Access Compliance Report

Public Rights-of-Way (Curb Ramps)

Intersection ID: 30450	Main Street: STEELE_CREEK_RD	Cross Street: SMOKE_MONT_DR	Location: NW
ADA ID: 4C63DB90583F	Ramp Type: Perp	Initial Pass/Fail: Fail	Overall Compliance: No
Severity Score: 12.5			
Codes/Mitigation Info/Possible Solution		Field Measurements/Component Compliance

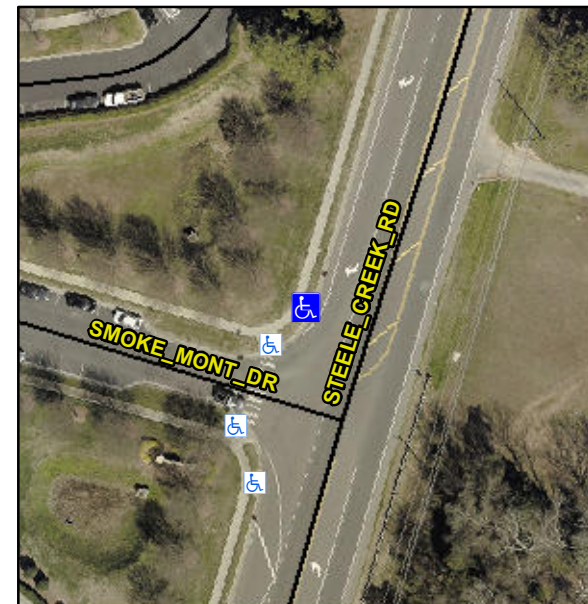
Not Found, R304.2.2

Compliance	Description	Data	Compliance	Description	Data
N/A	Ramp Length (in)	54.0	No	Ramp Slope (%)	11.1
Yes	Ramp Width (in)	48.0	Yes	Ramp XSlope (%)	0.8
N/A	Flare Type LT	N/A	N/A	Flare Type RT	N/A
N/A	Flare Slope LT (%)	N/A	N/A	Flare Slope RT (%)	N/A
N/A	Flare Traversable LT?	N/A	N/A	Flare Traversable RT?	N/A
N/A	Landing Length (in)	N/A	N/A	DWS Provided?	N/A
N/A	Landing Width (in)	N/A	N/A	DWS Contrast?	N/A
N/A	Landing Slope (%)	N/A	N/A	DWS Length (in)	N/A
N/A	Landing X Slope (%)	N/A	N/A	DWS Full Width?	N/A
N/A	Landing Curb? (Y/N)	N/A	N/A	DWS Offset (in)	N/A
N/A	Shared Landing?	N/A			
N/A	Gutter Ponding?	N/A	N/A	Gutter Slope (%)	N/A
N/A	Gutter Lip Ht (in)	N/A	N/A	Gutter X Slope (%)	N/A
N/A	Painted X Walk1?	No	N/A	Painted X Walk2?	N/A
	X Walk 1 Direction	To SE		X Walk 2 Direction	N/A
N/A	X Walk 1 Width (in)	N/A	N/A	X Walk 2 Width (in)	N/A
	X Walk 1 Slope (%)	2.0		X Walk 2 Slope (%)	N/A
	X Walk 1 X Slope (%)	1.2		X Walk 2 X Slope (%)	N/A

Remove & Replace Entire Ramp.
